IA-32 Intel[®] Architecture Software Developer's Manual

Documentation Changes

September 2003

Document Number: 252046-005

Figure 8-24. Layout of the MSI Message Data Register

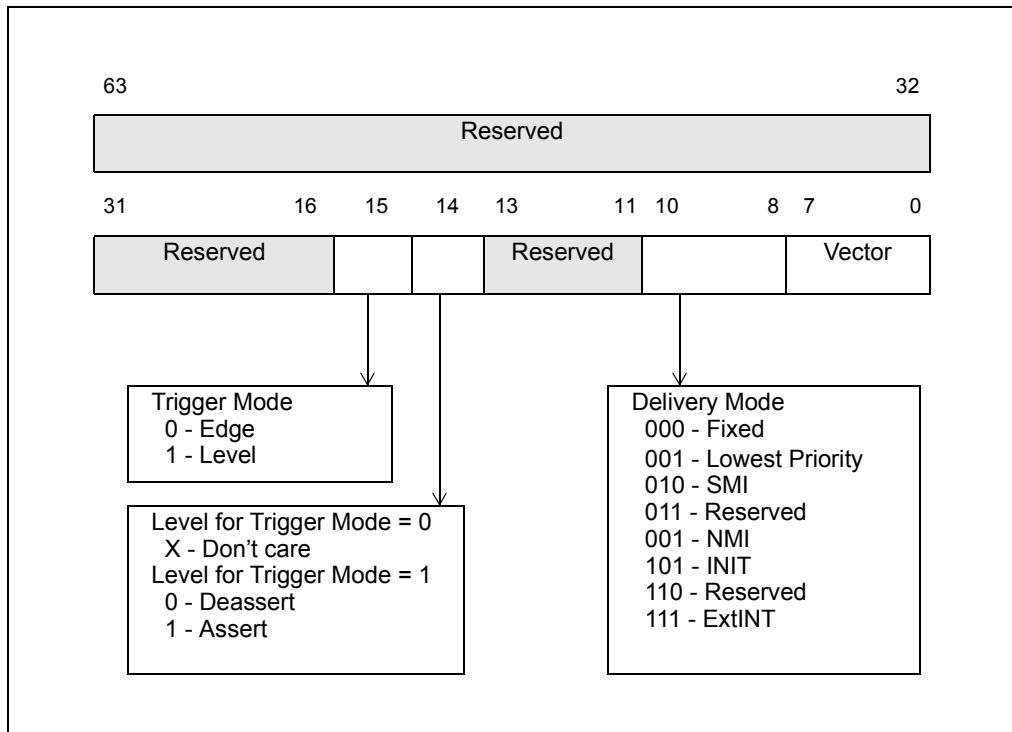
5. Typo Corrected in Figure 8-24

ExINT should be ExtINT in Figure 8-24, located in the “Message Data Register Format” section, Chapter 8, *IA-32 Intel Architecture Software Developer's Manual, Volume 3*. The corrected figure is reproduced below.

6. Typo Corrected in Figure 8-23

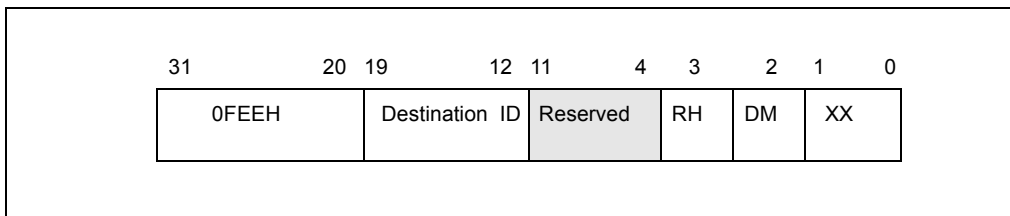
0FEEH was incorrectly represented as 0FEEEH in Figure 8-23, located the “Message Address Register Format” section, Chapter 8, *IA-32 Intel Architecture Software Developer’s Manual, Volume 3*.

The corrected figure is reproduced below.

Figure 3-20. Format of Page-Directory-Pointer-Table, Page-Directory, and Page-Table Entries for 4-Kbyte Pages with PAE Enabled

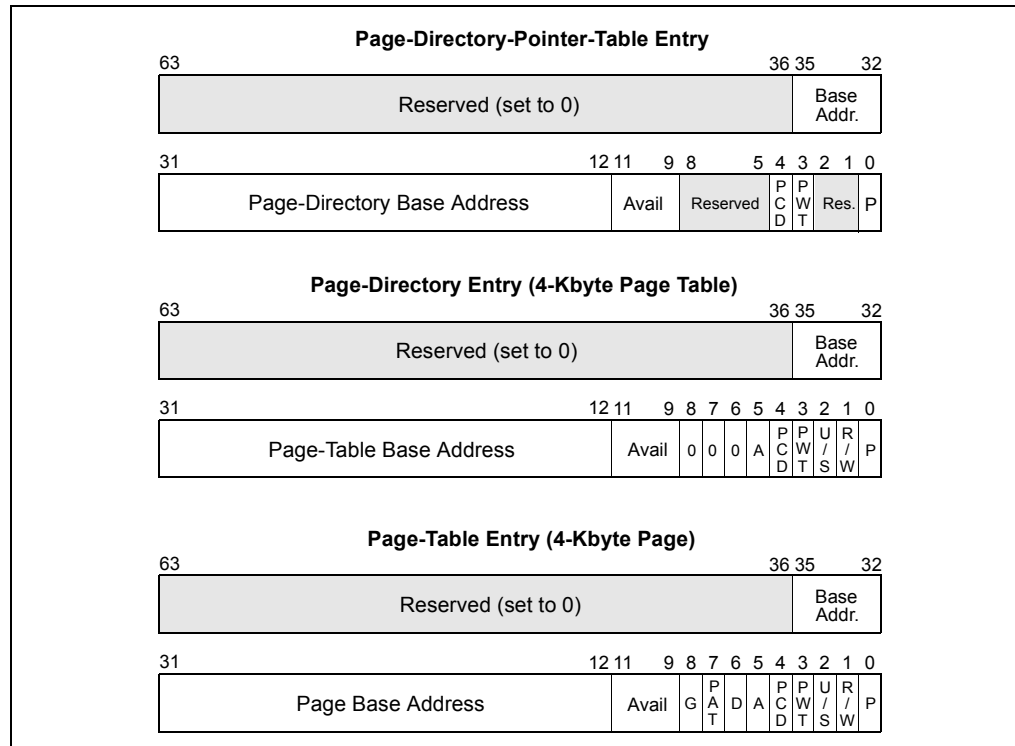
14. Corrections to Page-Directory-Pointer-Table Entry Description

In Figure 3-20 and 3-21, located in the “Page-Directory and Page-Table Entries With Extended Addressing Enabled” section, Chapter 3, *IA-32 Intel Architecture Software Developer’s Manual, Volume 3*; Bit 0 of both representations of the Page-Directory-Pointer-Table Entry now indicate P (showing the location of the ‘present flag’ bit).

The present flag (bit 0) in the page-directory-pointer-table entries can be set to 0 or 1. If the present flag is clear, the remaining bits in the page-directory-pointer-table entry are available to the operating system. If the present flag is set, the fields of the page-directory-pointer-table entry are defined in Figure 3-20, for 4-Kb pages, and Figure 3-21 for 2-Mb pages.
